Subject: VIRGIL C. SUMMER NUCLEAR STATION (VCSNS)
DOCKET NO. 50/395
OPERATING LICENSE NO. NPF-12
REQUEST TO USE ALTERNATIVES TO ASME BOILER
AND PRESSURE VESSEL CODE, SECTION XI
RR-II-15, RR-II-16, RR-II-17, RR-II-18, RR-II-19, RR-II-20, RR-II-21

**South Carolina Electric & Gas Co. (SCE&G)
Virgil C. Summer Nuclear Station (VCSNS)
Relief Request**

RR-II-15

V.C. SUMMER UNIT 1 REACTOR VESSEL FLANGE TO UPPER SHELL WELD

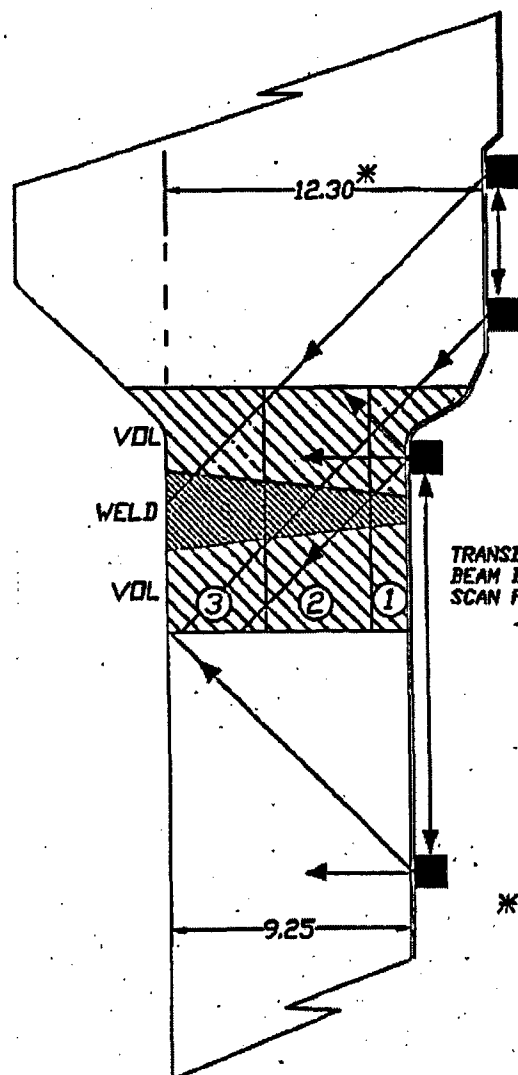
- (c) Compatibility of the Appendix VIII Technique to the VCSNS Flange to Shell Weld Joint and Synergy with the Previous Examination. The Appendix VIII shell weld examination procedure requires the use of one beam angle, 45 degrees, applied to the weld and volume using 3 different transducer types each covering a specified depth range. The procedure requires the exam volume to be crosshatched with sound beams in four orthogonal directions. The increment size is 0.5 inch. Coverage is estimated in the attached sketch. From the sketch, the critical inner 15 percent is well interrogated with the exception of area directly beneath the curved surface above the weld. This is a common limitation for the flange to shell weld joint.

The last remote mechanized exam of the flange to shell weld was conducted in 1993. At that time 45, 60 and 70 degree exam angles were used, and the results were acquired and analyzed using an automated ultrasonic exam system. The increment size was 0.5 inch, and the exam method was contact. Results from the exam were that no indications were found exceeding the allowable limits of Section XI. There is excellent data archival from the 1993 exam, and SCE&G is confident that reasonable comparisons can be made with the Appendix VIII examination if any questions arise concerning indications.

SCE&G will ensure that the flange to shell weld of the VCSNS reactor vessel will be examined with proven qualified ultrasonic examination techniques in lieu of standard amplitude based ultrasonic examination techniques currently specified. Examinations will be conducted to the maximum extent practical in four orthogonal directions. The examination sensitivity and flaw measurement capability of the proposed alternative are superior to the method prescribed and coverage will be good considering the difficult geometric presentation.

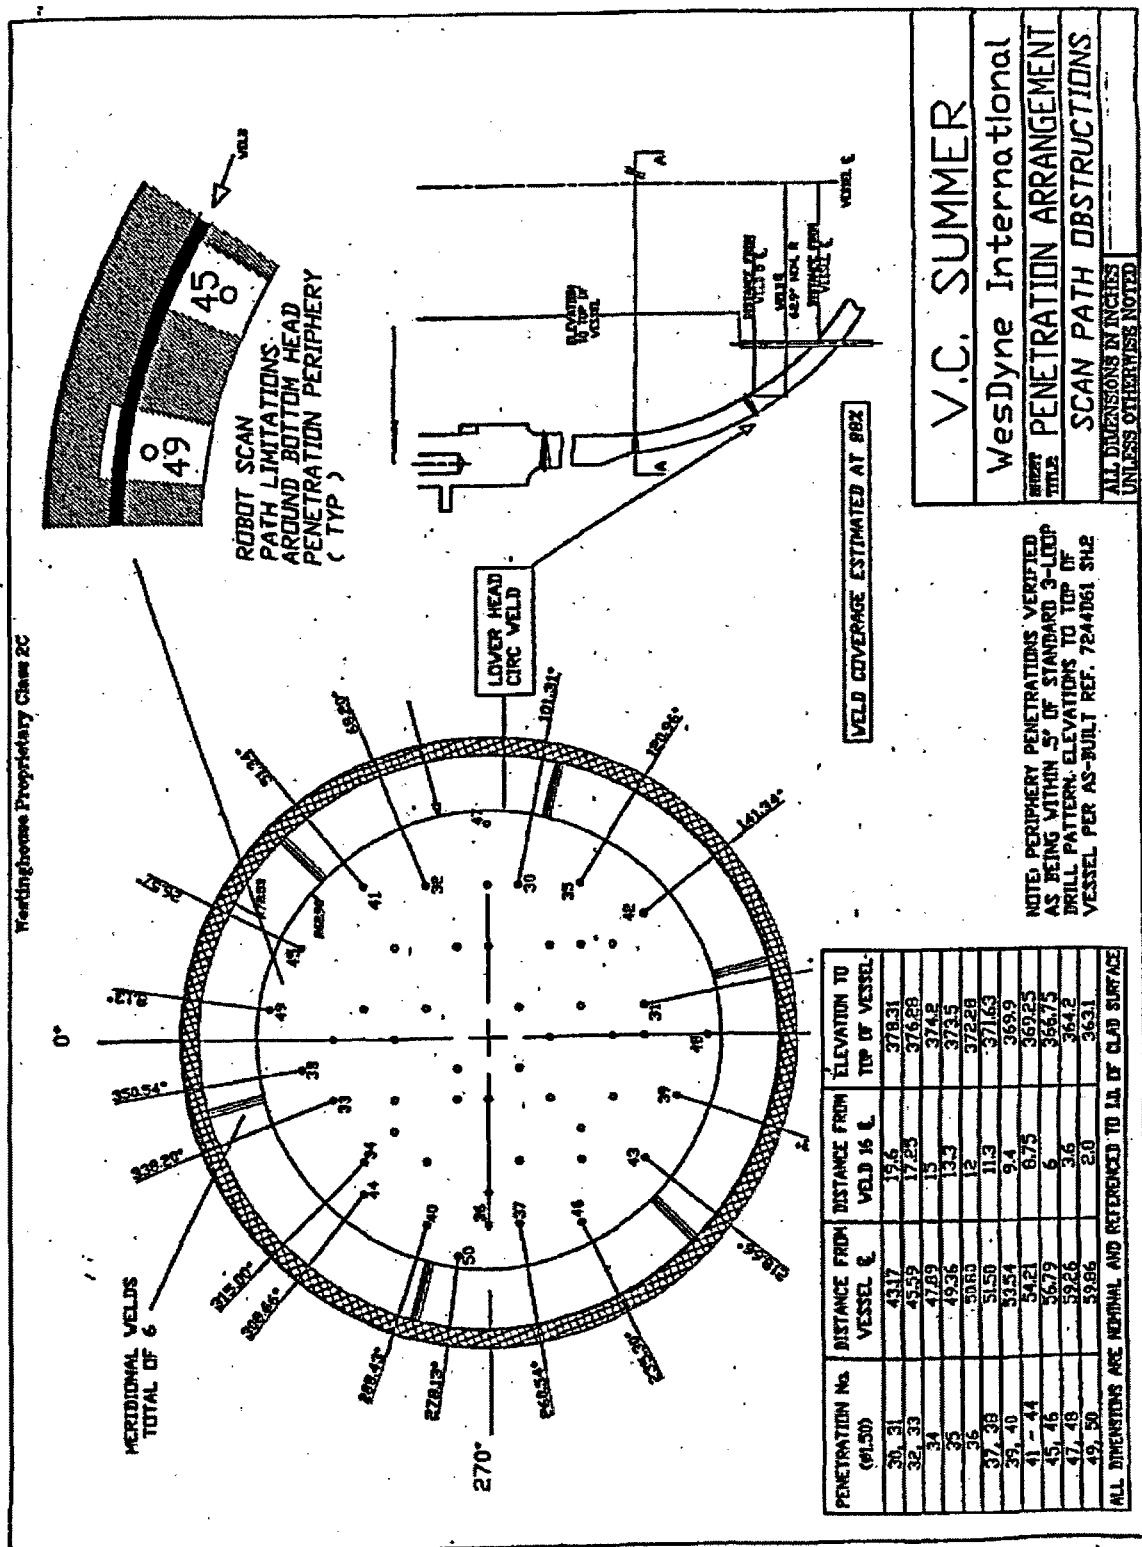
In accordance with 10CFR50.55a(a)(3)(i), SCE&G proposes to examine the lower head circumferential weld to the maximum extent practical using advanced robotics for contact examination. Complete ultrasonic interrogation is anticipated to be 88 percent of the weld length. The normal scanning path of the transducer package is obstructed and partially obstructed by the outermost grouping of lower head penetrations.

Ultrasonic examinations of the VCSNS reactor vessel lower head circumferential weld can be accomplished for approximately 88 percent of the length of the weld. A small portion of the weld length cannot be examined due to obstructions from the periphery of the lower head penetrations. An engineering sketch is provided for approximate weld coverage and penetration orientation. The proposed examination will provide an acceptable level of quality and safety.

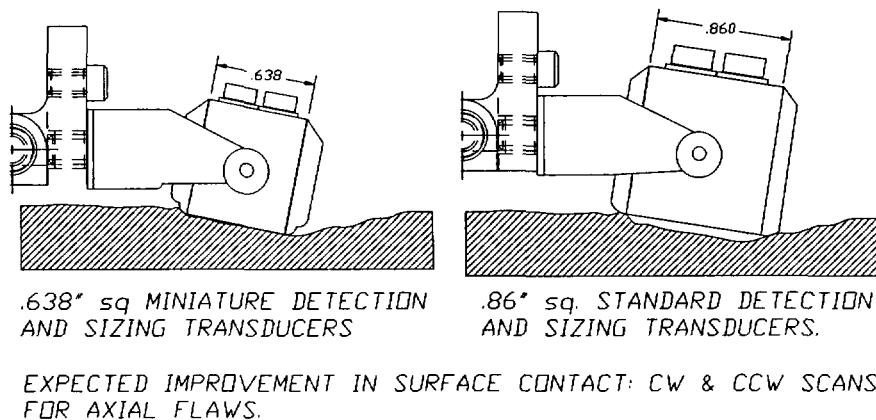
- 1) Regular 22mm x 22mm transducers for detection of circumferential defects. This is the "standard technique" qualified for detection and length sizing. These transducers will also be used initially for axial defect scans.
- 2) 100% profiling of all nozzle to primary piping DM weld ID surfaces (Hot Leg and Cold Leg).
- 3) Evaluation of the raw data for transducer contact and profile data for supporting evidence. Areas of insufficient contact will be re-examined with miniature transducers.

The expected differences in transducer performance are illustrated:
